# Conceptual Review Agenda

Schedule for 03/17/14 to 03/17/14

# 906 E Stuart St Child Care

**Re:** 906 E Stuart St - Child Care

# Scenario I

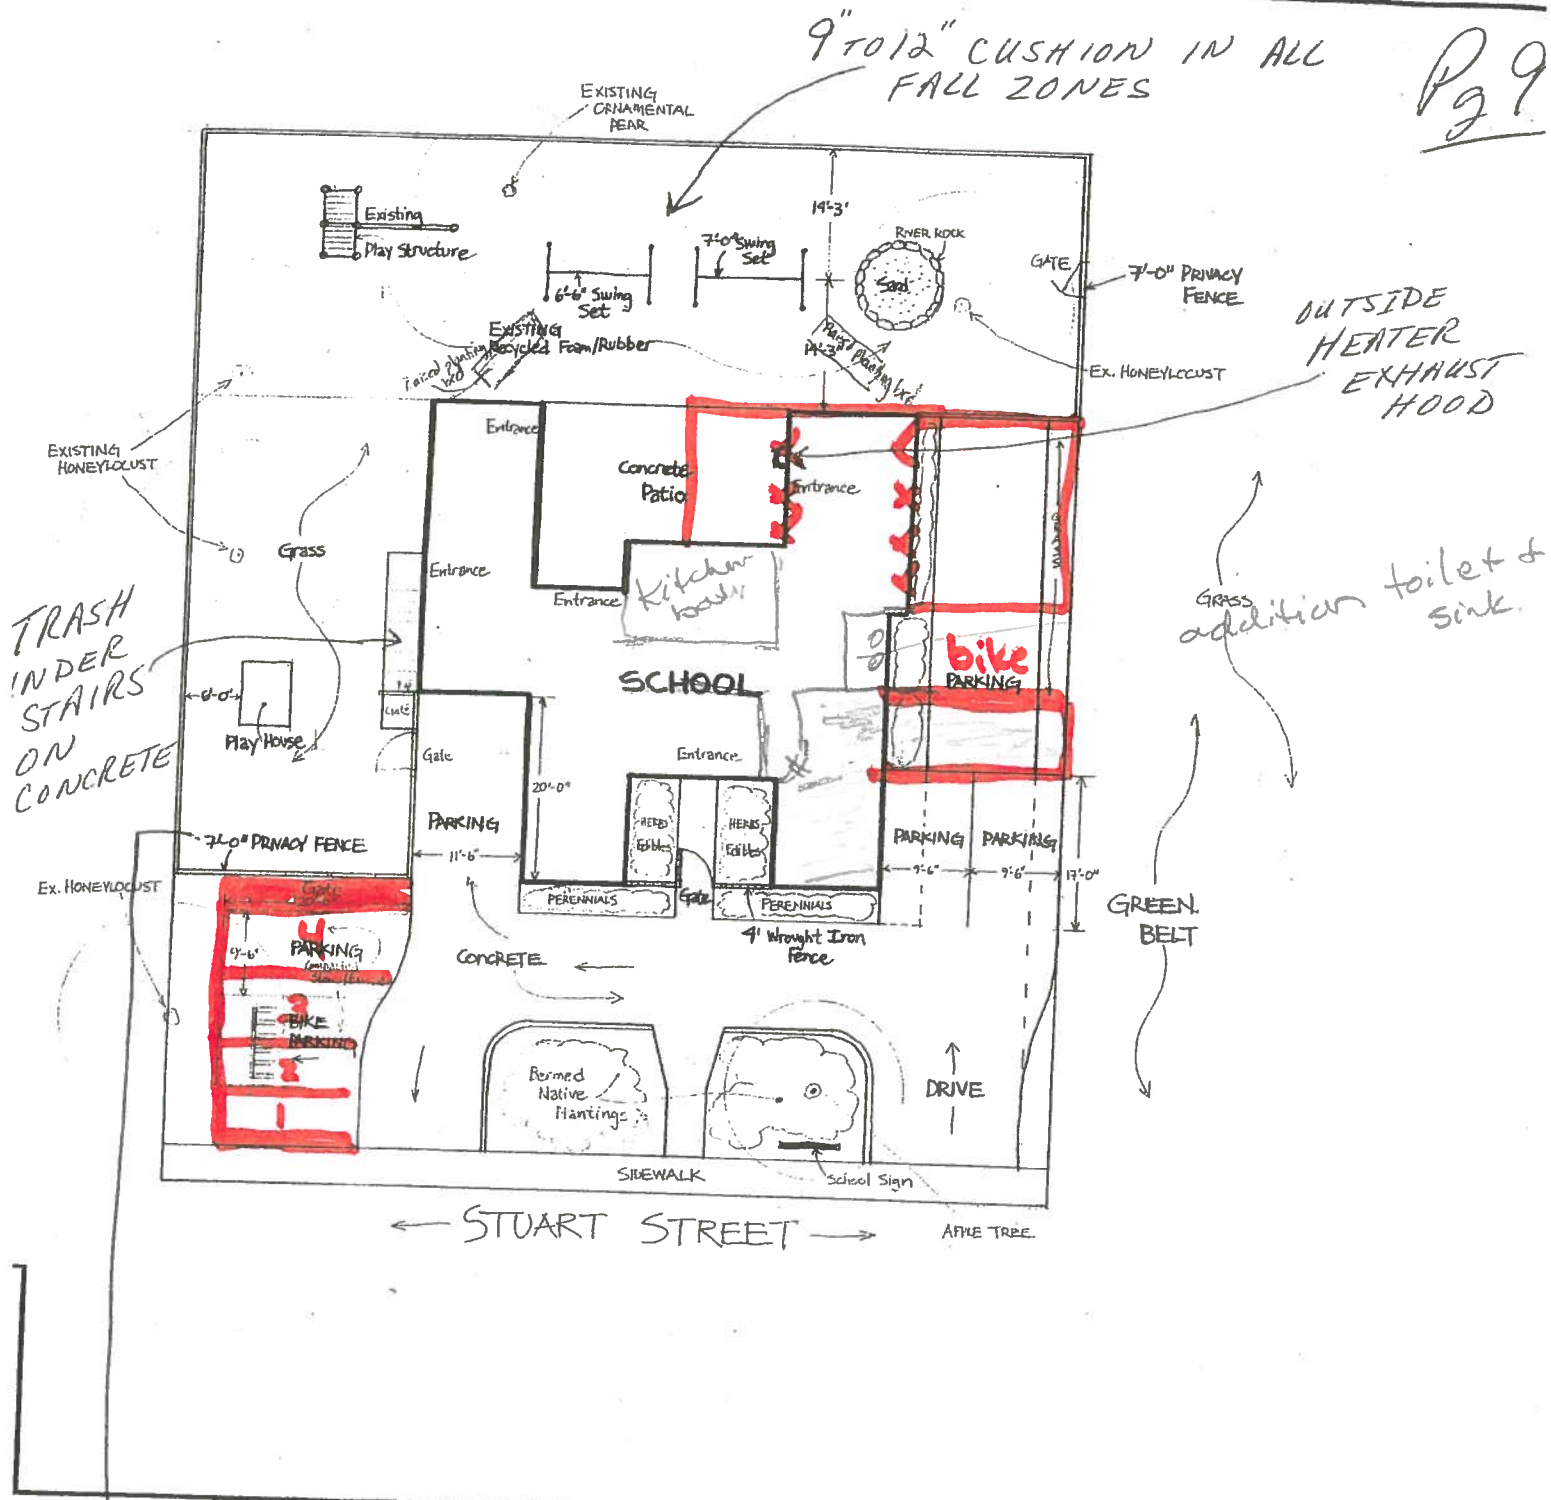
1. Scenario 1 could be done with a minor amendment, the addition would need to remain under 518 SF.

# Scenario II

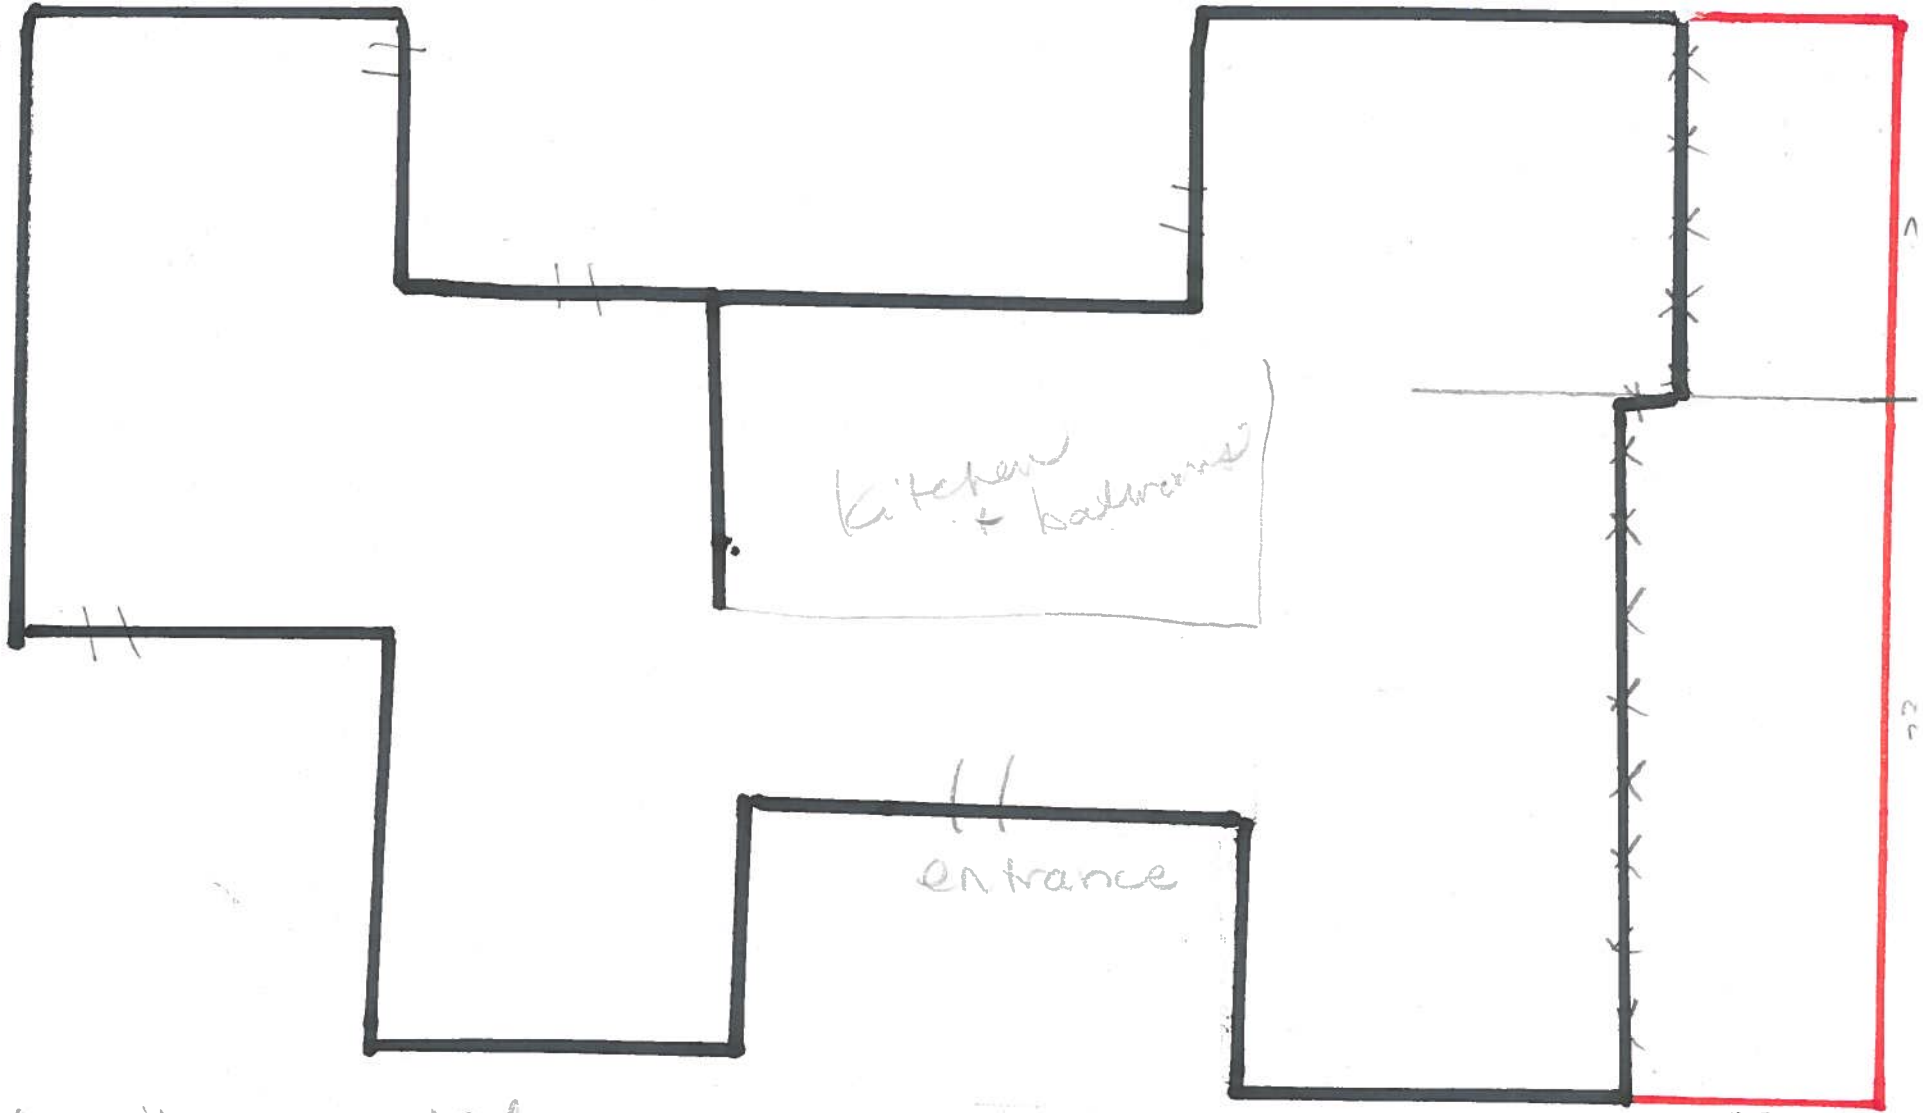
Scenario 2 would require the property to be platted.
